CITY OF ALBUQUERQUE

Re: Approval of Final Certificate of Occupancy (C.O.) for
Glass-Rite Warehouse, [L-14 / D037]
808 Gibson Blvd SE
Architect's Stamp Dated 07/25/08

**Re: Glass-Rite Building Addition,
808 Gibson Blvd. SE,
Reject of Request for Permanent Certificate of Occupancy (C.O.)
Engineer's Stamp dated 09/11/2007 (L-14/D037)
Certification dated 05/19/2008**

**Re: Glass-Rite Bldg Addition, Lot 6A1 Block B Torreon Addition, Grading and
Drainage Plan**

HOBBING: SLABS-RITE GRADING & DRAINAGE PLAN

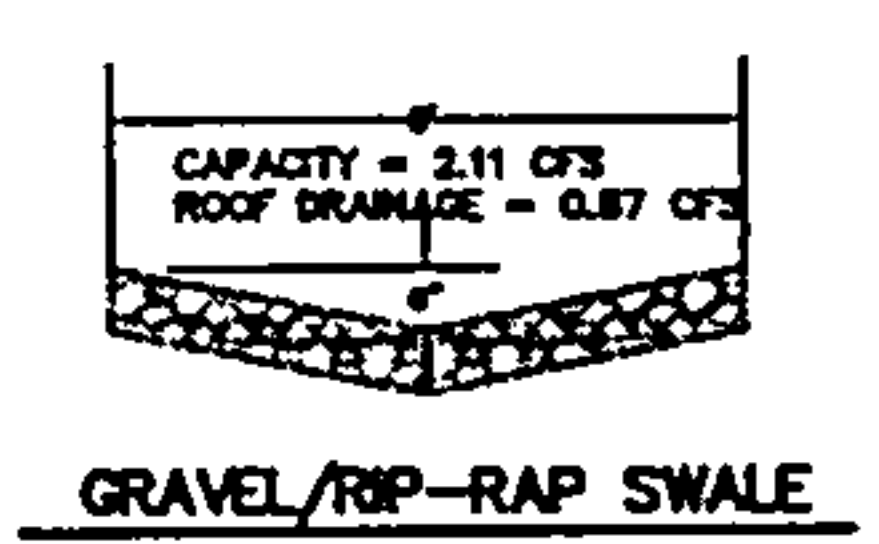
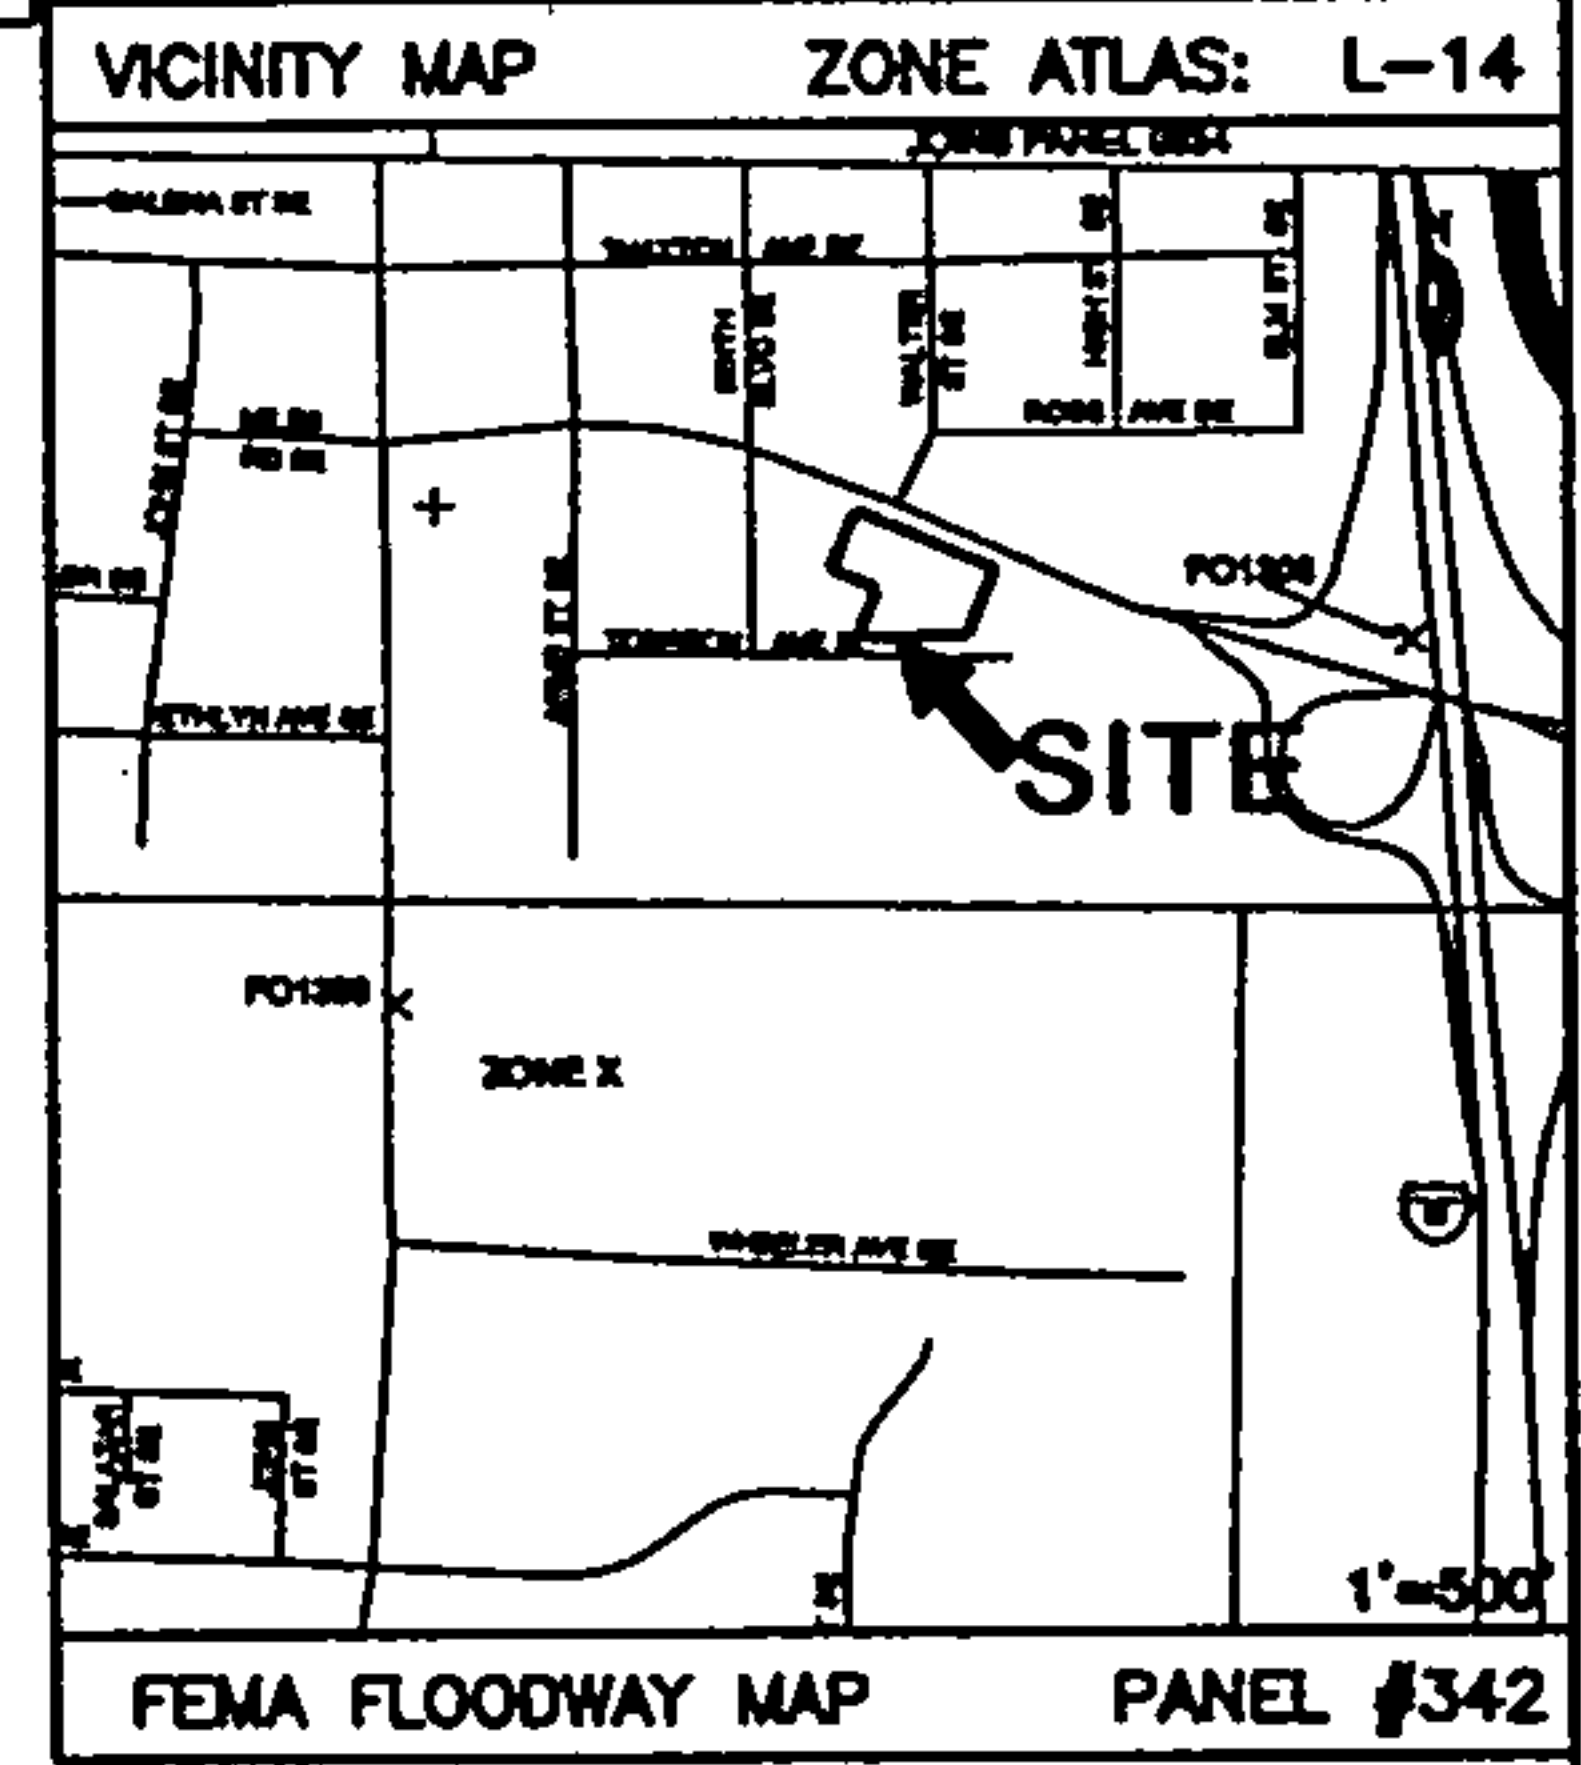
After a recent site visit the "2'-wide curb opening to drain swale" was not constructed. Now the addition drains across the handicapped ramp; this is unacceptable. Please correct this issue and resubmit for a permanent Certificate of Occupancy.

- Paving in the alley could be accomplished by the Work Order process. In addition, access to lots 1, 12 and 3 cannot be blocked. The ROW could be vacated.
- The drive entrance near the addition will have to be removed and the sidewalk replaced. If this area is to drain north, a sidewalk culvert would be required.
- The northwest corner of the addition overlaps the parking island/curb. Show proposed condition for this area.
